ATTACHMENT 4

UNIT 2 – AREA WALK-BY CHECKLISTS

NO. SNCV061-RPT-02

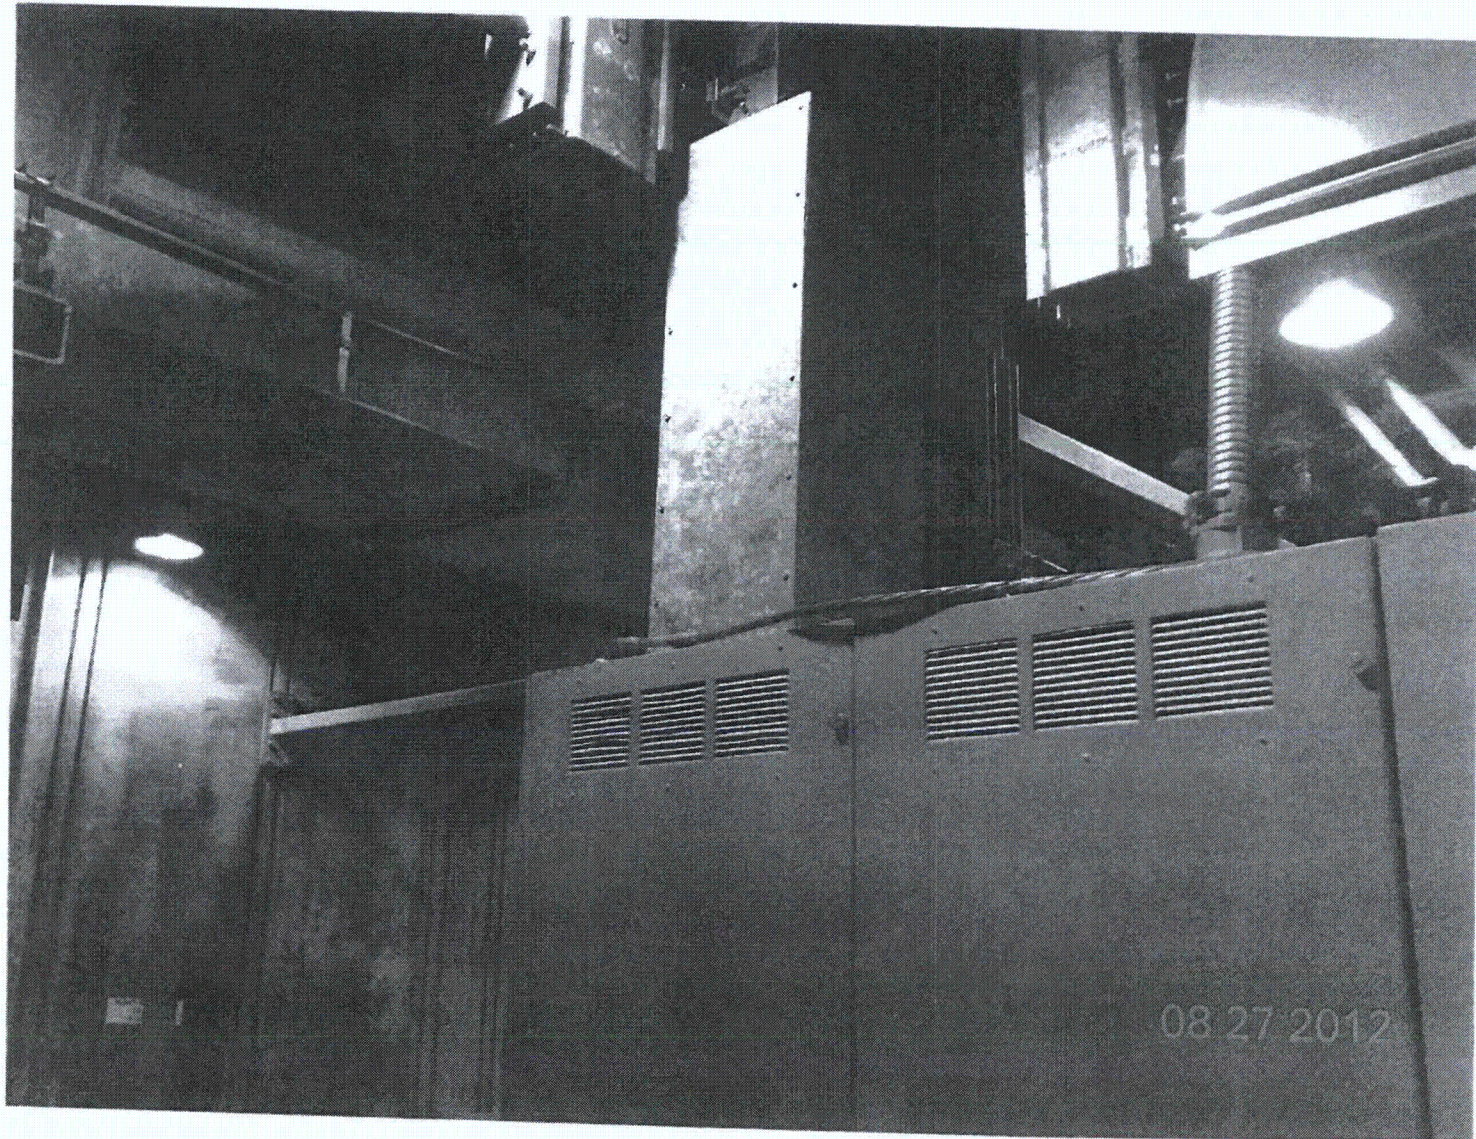
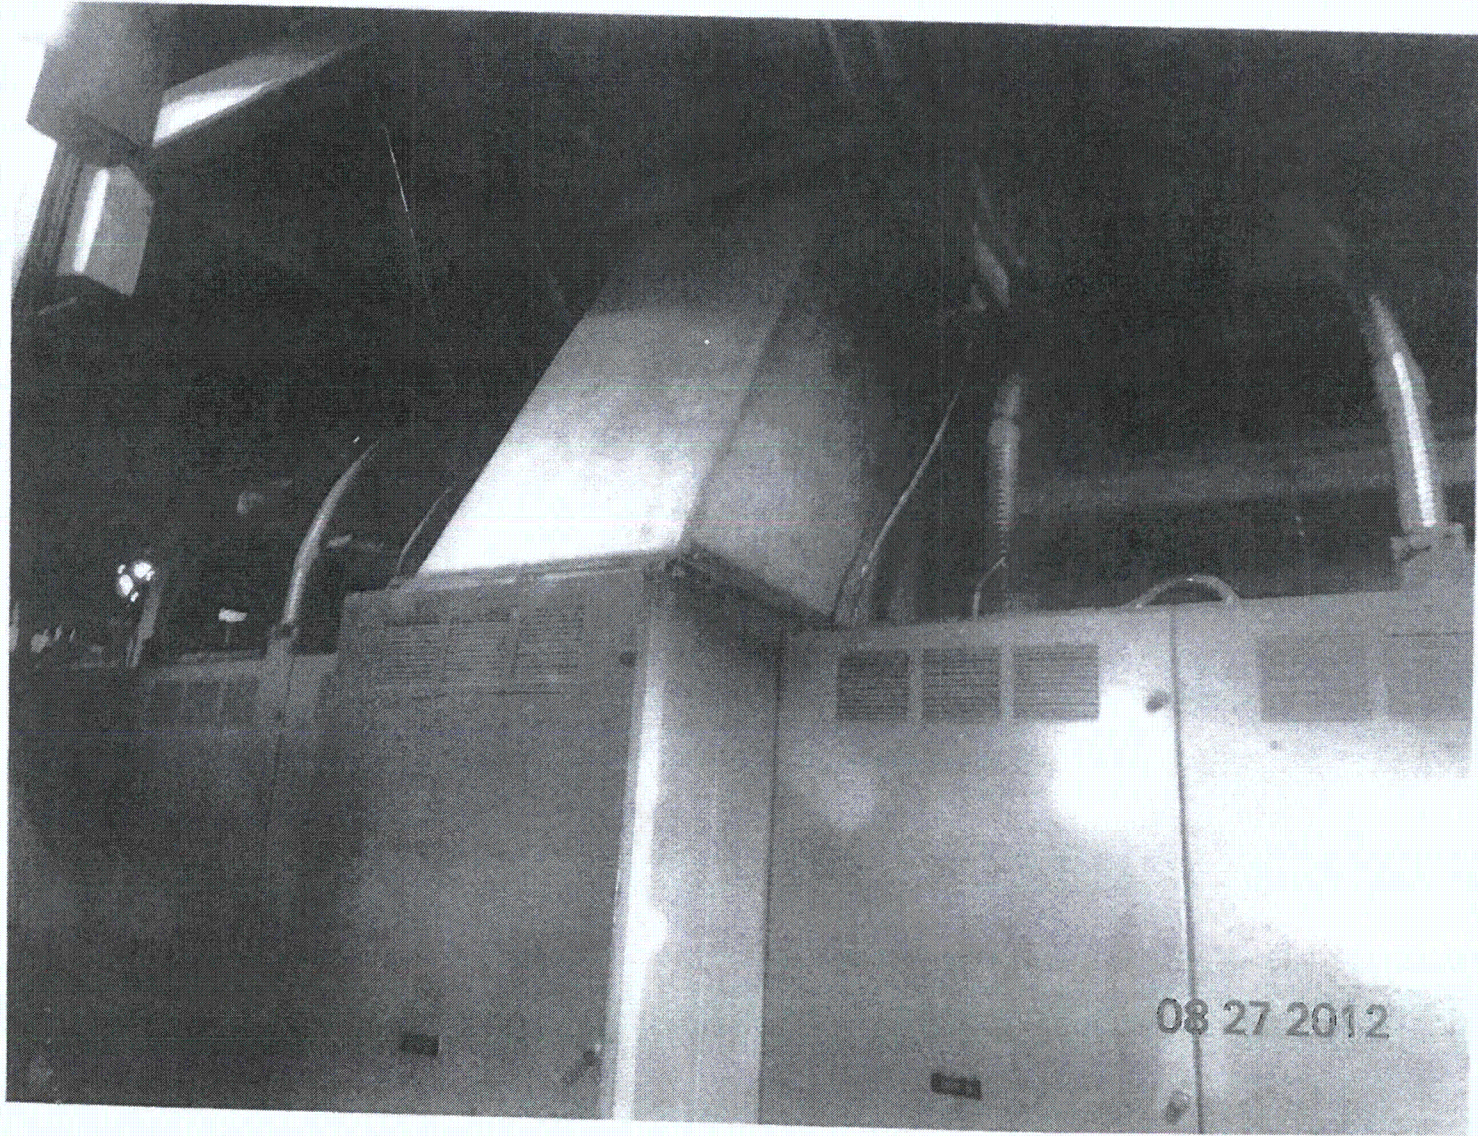
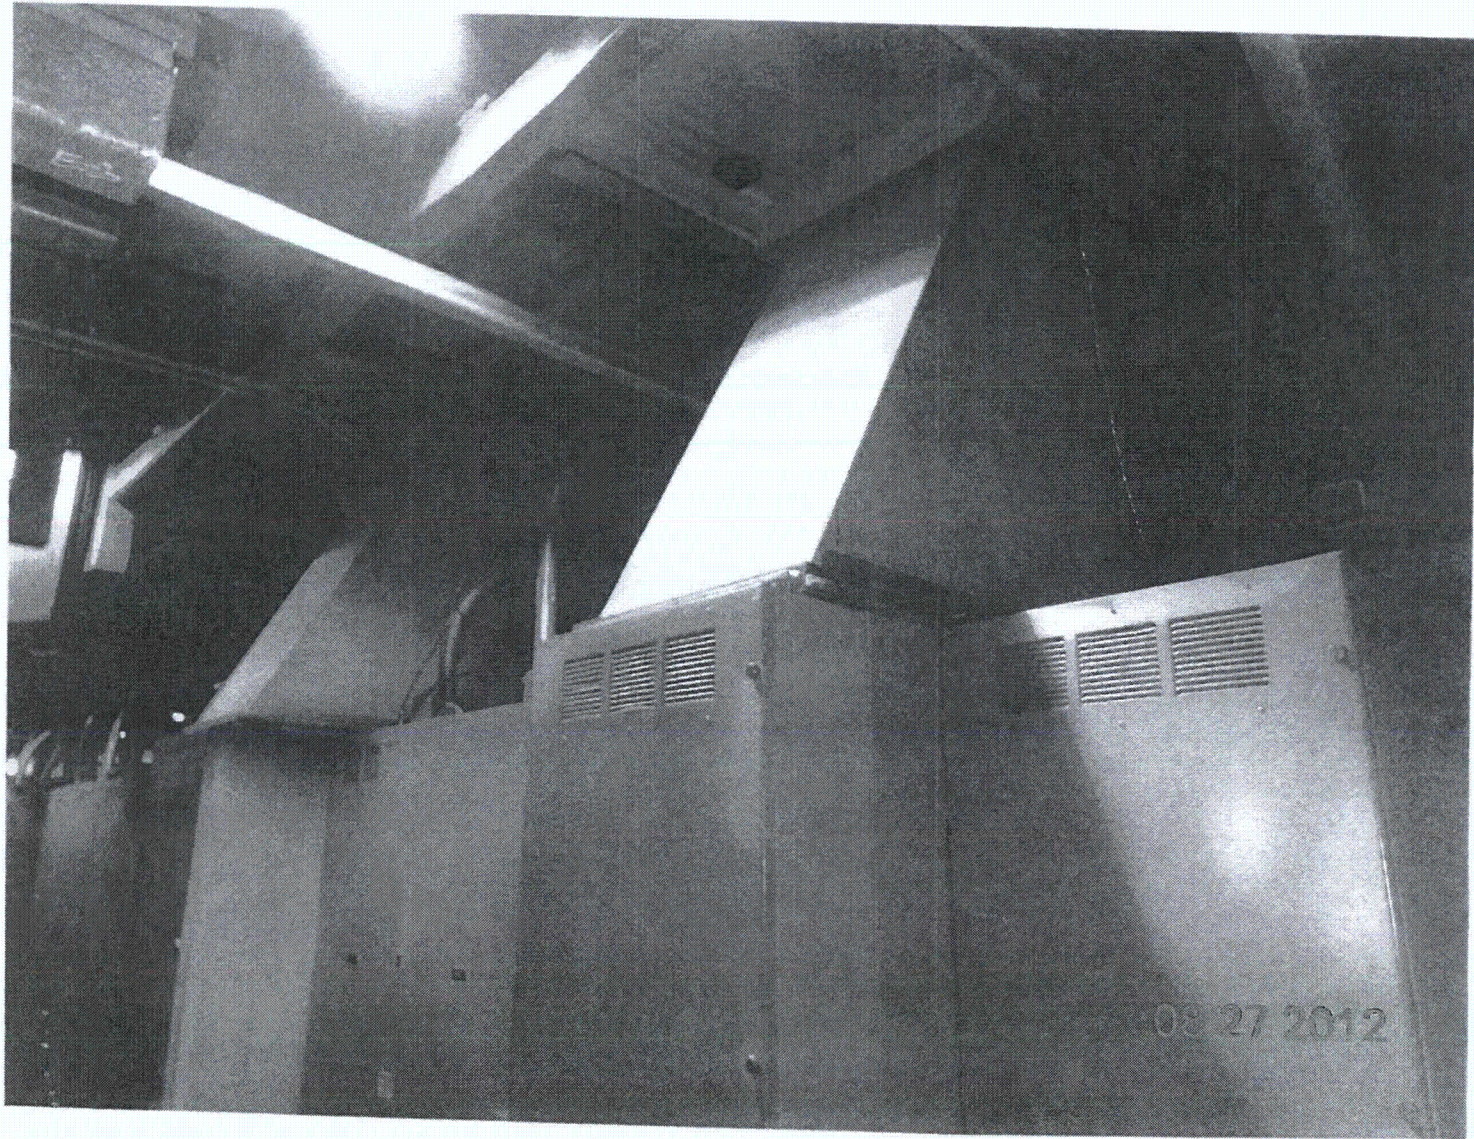
Cable tray extension connected to 2-1804-S3-A02 (A160Y Switchgear 2AA02) appears to be rigidly attached (bay 2AA02-22). Two (2) ^{new} ~~new~~ extensions at top of same cabinet appear to be rigidly attached (at bays 2AA02-01 and -05). Refer to CR 517078.
